Name Of Dam: GEORGE F. BRASFIELD

Inventory Number: VA 04101

PHASE I INSPECTION REPORT

NATIONAL DAM SAFETY PROGRAM

GEORGE F. BRASFIELD - VIEW OF BANK EROSION ON D/S SLOPE
OF RIGHT ABUTMENT

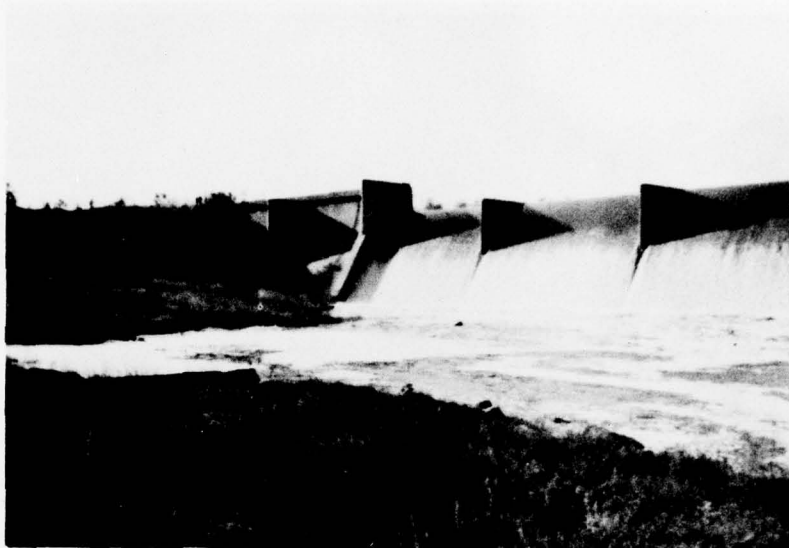
1.2.1 Observations: The abutments of the concrete dam are composed of weathered granite and residual clays. A majority of the abutment slopes are grassed. Despite the grass cover, serious erosional gullies have developed on the downstream slope of the right abutment. This erosion has steepened the downstream slopes (lv to lh) and reduced the fill adjacent to the dam. In addition to the erosion, minor shoreline erosion was noted on the upstream slope of the left abutment.

1.2.2 Recommendations: The erosion on the downstream slope of the right abutment should be corrected immediately to prevent further deterioration of the abutment. In addition to grading and seeding, a paved channel should be constructed to divert surface runoff from the upper slopes to the river. The erosion of the upstream shoreline adjacent to the dam can be arrested by the use of rip-rap and filter cloth.

7.2.1 Remedial Action: The erosion of the abutment slopes should be corrected as soon as possible to prevent a potential problem from developing. It is suggested that the areas affected by the surface erosion be stabilized by proper grading and seeding techniques. In conjunction with this treatment, the surface runoff from the surrounding slopes should be diverted to the river via a paved channel to prevent further erosion. Riprap should be used to arrest the upstream shoreline erosion.
